Application No.	Applicant(s)				
Office Action Comments	10/578,112	FRIESE ET AL.				
Office Action Summary	Examiner	Art Unit				
	VLADIMIR IMAS	2839				
The MAILING DATE of this communication appears on the cover sheet with the correspondence address Period for Reply						
A SHORTENED STATUTORY PERIOD FOR REPLY IS SET TO EXPIRE 3 MONTH(S) OR THIRTY (30) DAYS, WHICHEVER IS LONGER, FROM THE MAILING DATE OF THIS COMMUNICATION. - Extensions of time may be available under the provisions of 37 CFR 1.136(a). In no event, however, may a reply be timely filed after SIX (6) MONTHS from the mailing date of this communication. - If NO period for reply is specified above, the maximum statutory period will apply and will expire SIX (6) MONTHS from the mailing date of this communication. - Failure to reply within the set or extended period for reply will, by statute, cause the application to become ABANDONED (35 U.S.C. § 133). Any reply received by the Office later than three months after the mailing date of this communication, even if timely filed, may reduce any earned patent term adjustment. See 37 CFR 1.704(b).

DETAILED ACTION

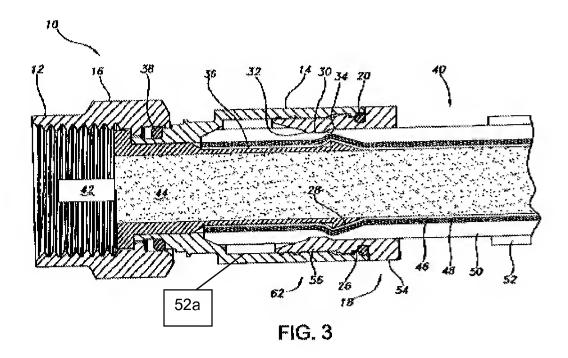
5. Applicant's arguments filed on May 8, 2008 have been fully considered but they are not persuasive. The Applicant argues "Derenthal does not constitute prior art against the present application under 35 U.S.C. § 102(b). In this regard, Derenthal issued on November 16, 2004, which is after the September 3, 2004 international filing date of the present application." The Examiner agrees that there was a typographical

error in the previous office action, however, the reference patent of Derenthal (US 6,817,896) still is a valid reference under 35 U.S.C. 102(e). The Applicant argues "Derenthal does not disclose, or even suggest, the feature that a segment of a sleeve is electrically conductively contacting a shield." The Examiner respectfully disagrees. It is clear from fig. 3 that segment 28 of a sleeve 36 contacting a shield and this contact will be conductive in case the segment is made from conductive material (to provide electrical connection with inner foil 46). The Applicant also argues "Derenthal does not disclose, or even suggest, the feature that an inner surface of a segment is slid onto an outer surface of a dielectric to widen a jacket in a region of the segment." The Examiner respectfully disagrees. The attached fig. 3 shows that element 52a of jacket is present in area of post and moreover the outer foil

50 could be considered as part of jacket.
